**RE: Response Letter  
Notice of Intent – Milhench Supply Co. (SE49-0809)  
127 Duchaine Blvd. – New Bedford, Massachusetts 02745**

## Nitsch Engineering Review Comments

1	9/18/18	PEER REVIEW	COMMENTS

#### SITE PLAN

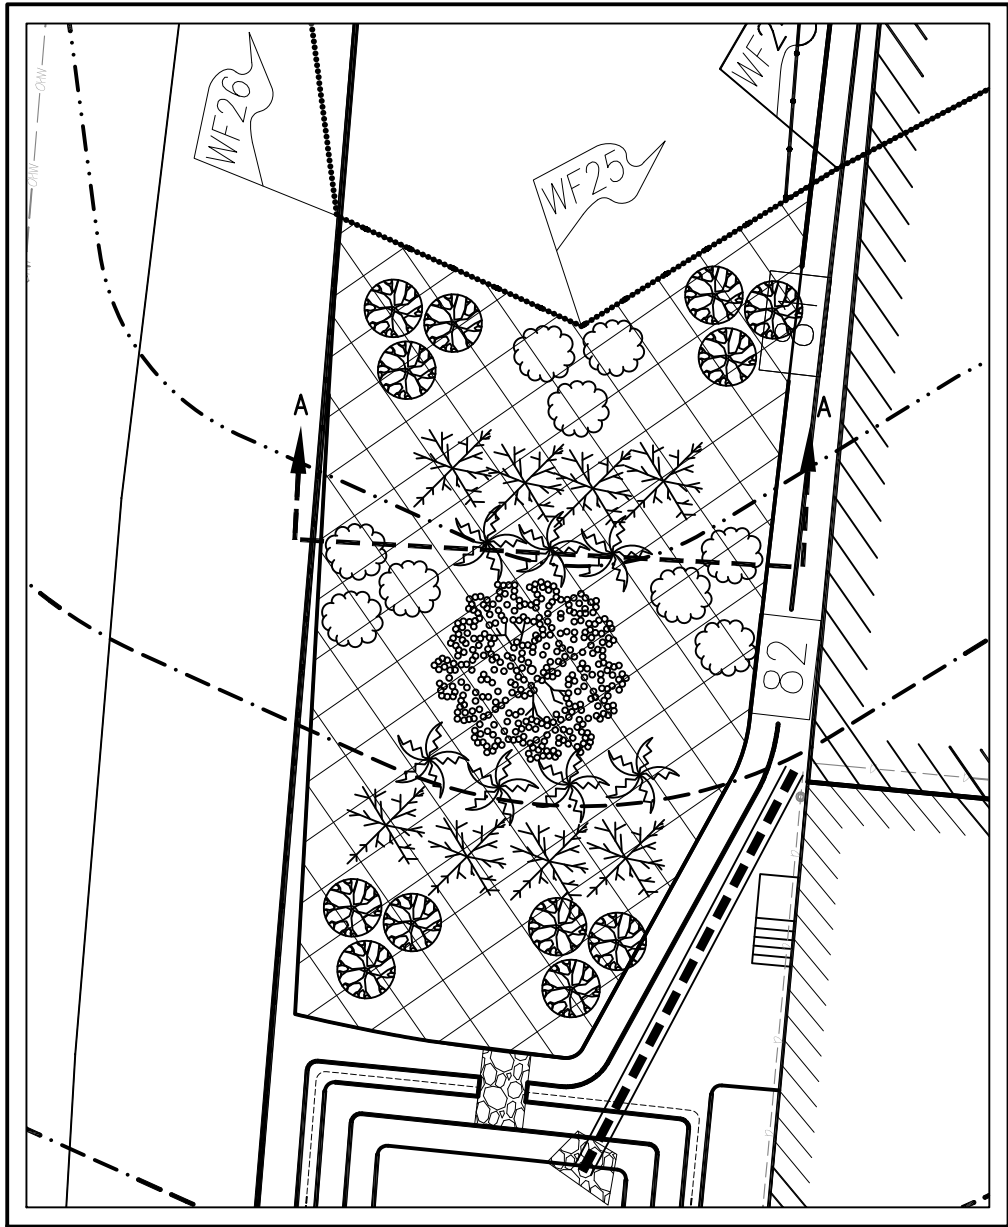
*Revise the Watering & Monitoring language on Sht. 6 to state that the Conservation Agent shall conduct inspections at the following times: after installation of the erosion controls and prior to excavation of the wetland replication areas; when the subgrade of the wetland replication areas have been excavated; and when the final grade and plantings are completed.*

*Remove Note 5 under Watering & Monitoring Notes (Sht. 6) and replace with the following:* In compliance with 310 CMR 10.55(4), the wetland professional shall submit monitoring reports documenting the success of the wetland replication areas. These reports shall document the establishment of at least 75% coverage of indigenous wetland plants within the replication area. These reports shall be provided at the end of construction and once a year for two years. The Conservation Commission reserves the right to request additional seeding or planting to guarantee the success of the replication areas. Proposed shrub and tree plantings that die during this time period shall be replaced. The reports shall also document the presence of invasive species within the replication area and recommend controls methods.

**These notes have been revised, as requested.**

**This note has been revised, as requested.**

- CONSTRUCTION SEQUENCE & NOTES**
1. THE WETLAND REPLICATION AREA SHALL BE CONSTRUCTED PRIOR TO ANY EARTH DISTURBANCE REQUIRED FOR THE PROPOSED PROJECT.

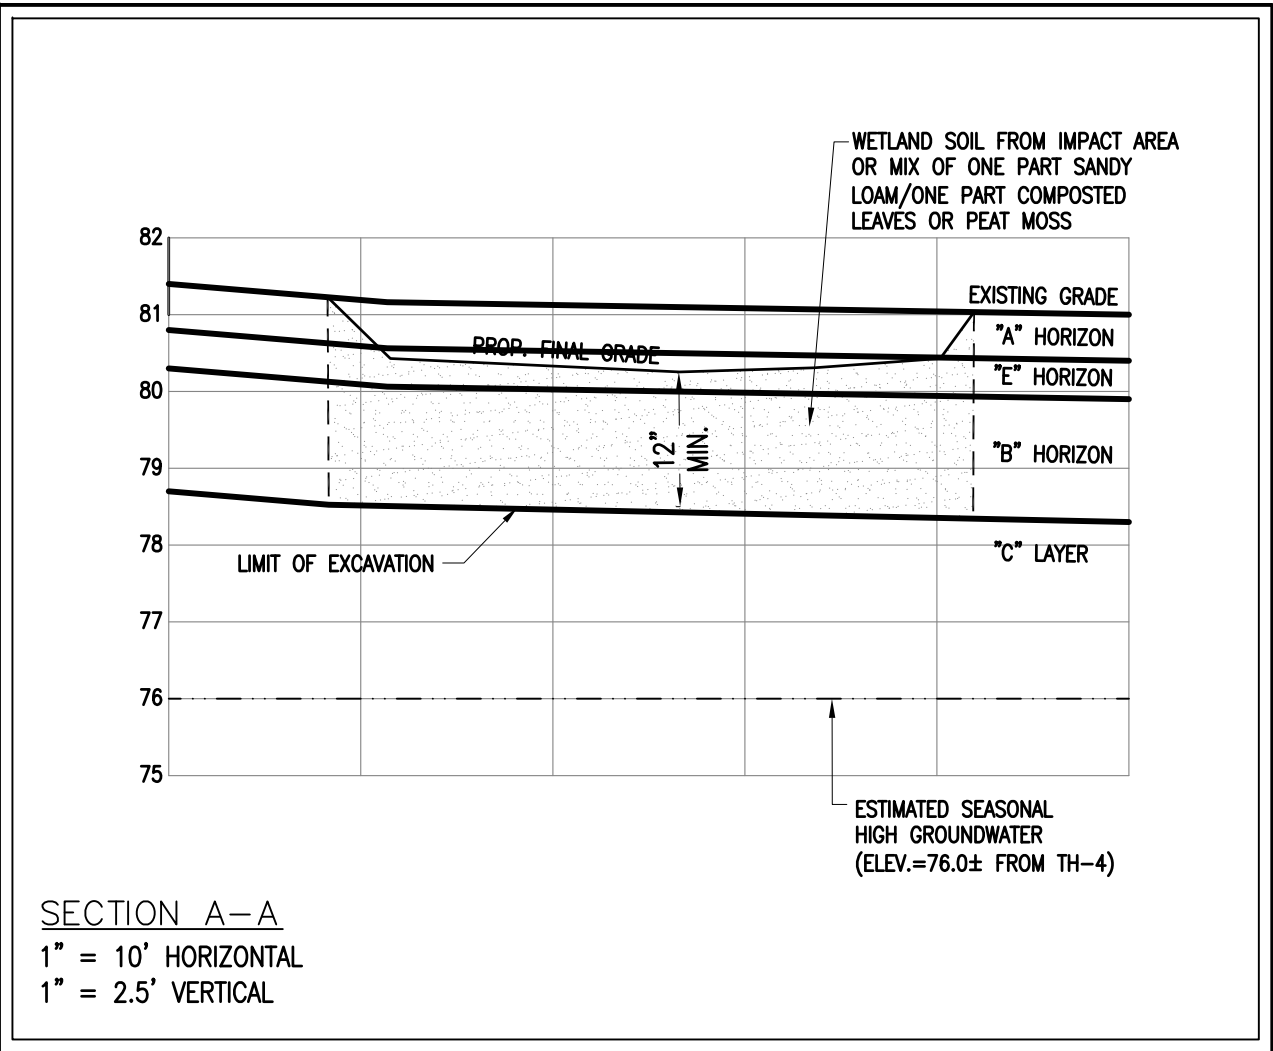
*Place the following notes on the plan under the Construction Sequence & Notes (Sht 6):*

- a. The final elevations of the wetland replication area shall be shown on an as-built plan (0.50' contours) and stamped by a Massachusetts Professional Land Surveyor. A copy of the stamped as-built shall be provided to the New Bedford Conservation Commission for acceptance prior to the wetland plantings.
- b. The seasonal high groundwater elevation in the wetland replication area shall be verified by a Certified Soil Scientist, Wetland Professional or Professional Civil Engineer prior to backfilling the replication area. The elevation of the seasonal high groundwater elevation shall be provided to the Conservation Agent along with verification that it will support the proposed wetland plantings.

**These notes have been added to the plan set, as requested.**

**WETLAND REPLICATION (TOTAL AREA=7,600 S.F.)**

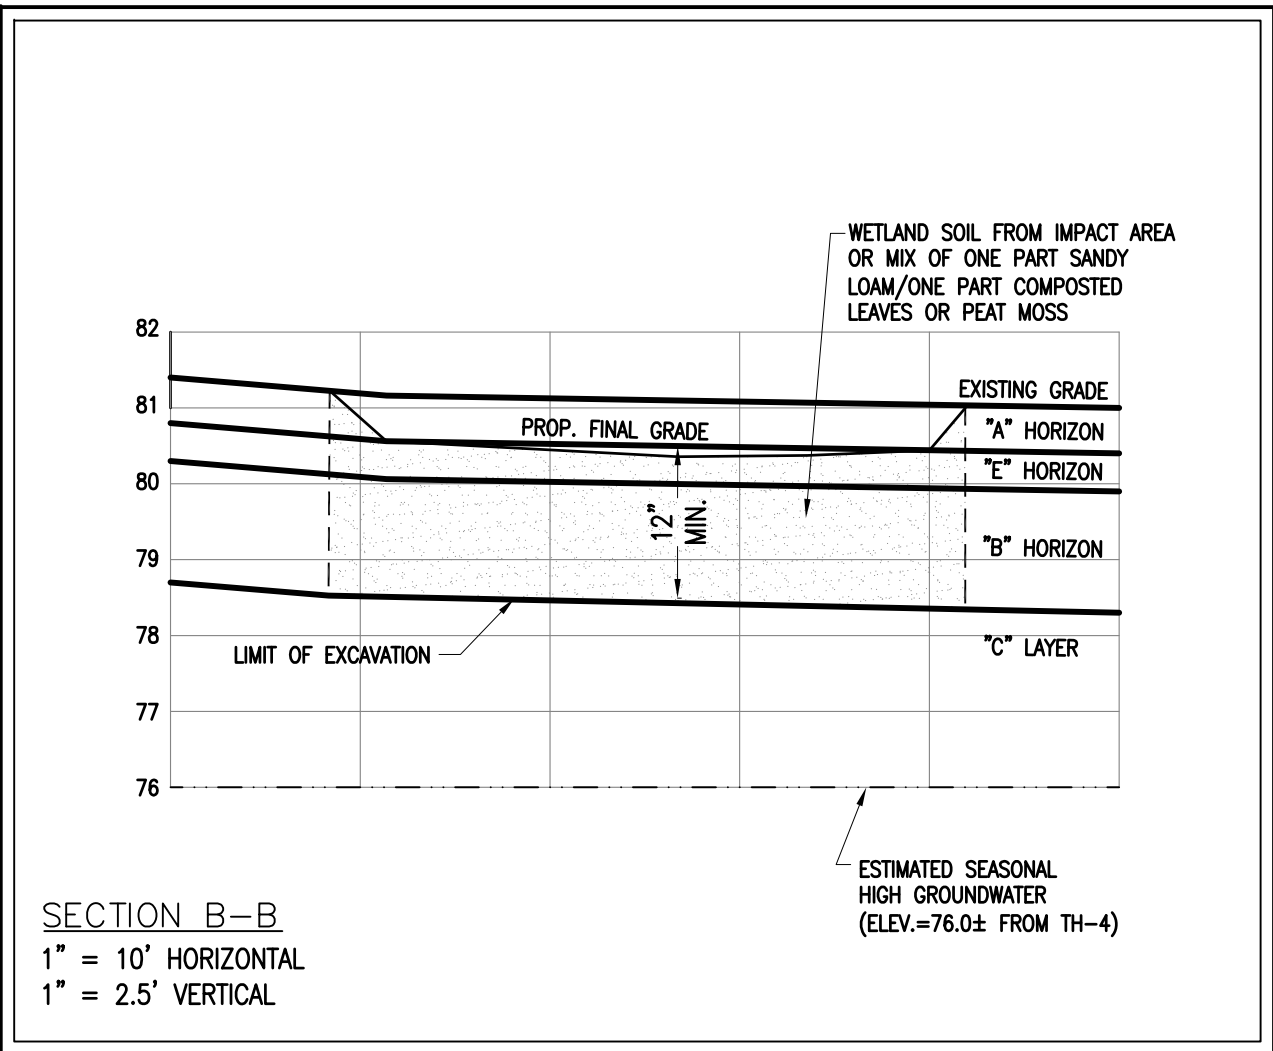
*Please provide a cross section through each of the wetland replication areas including the depth of over-excavation, the seasonal high water elevation, the final elevation of the wetland replication area and plantings.*

**This detail and requested information has been added to the plan set.**

INFILTRATION BASIN

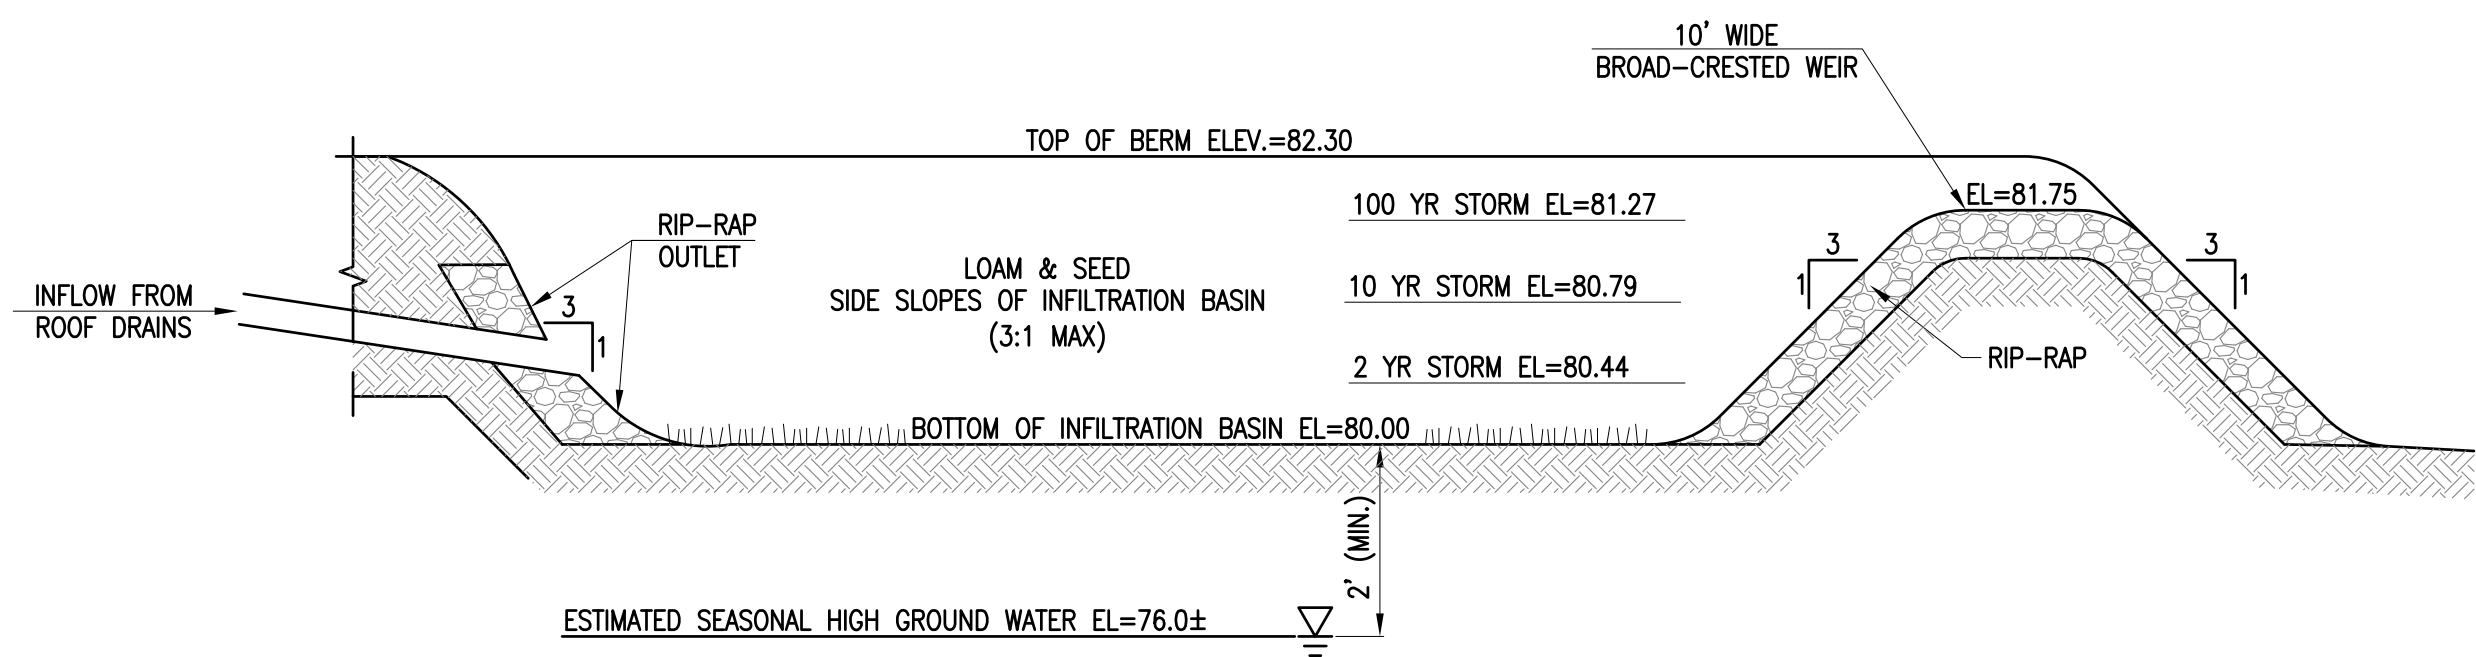
*The top of the infiltration basin is at elevation 82. The 100-year flood elevation in the basin 81.76. We recommend the top of the basin be elevated to provide one-foot of freeboard consistent with the Stormwater Management Guidelines.*

*We recommend that a detail of the infiltration basin with the overflow structure be added to the plans.*

**The proposed basin has been revised to allow for the adequate amount of storage while allowing for at least one-foot of freeboard.**

**This detail has been added to the plan set, as requested.**

FLARED END OUTLET

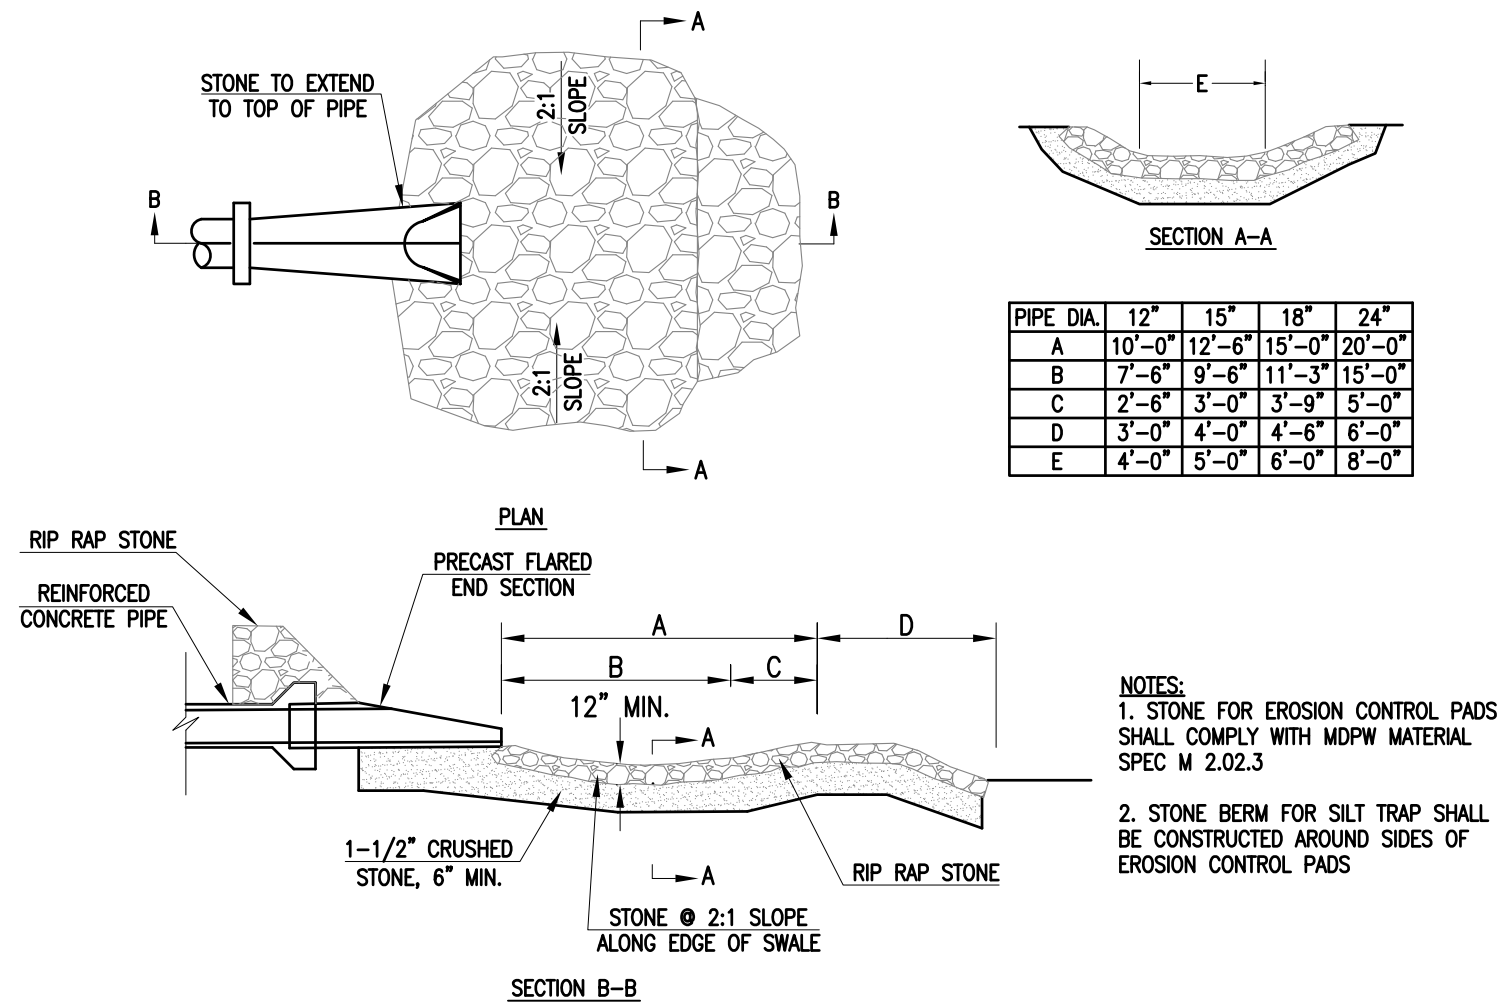
*We recommend that a detail of the rip-rap pad at the discharge point into the infiltration basin be added to the plans.*

**This detail has been added to the plan set, as requested.**
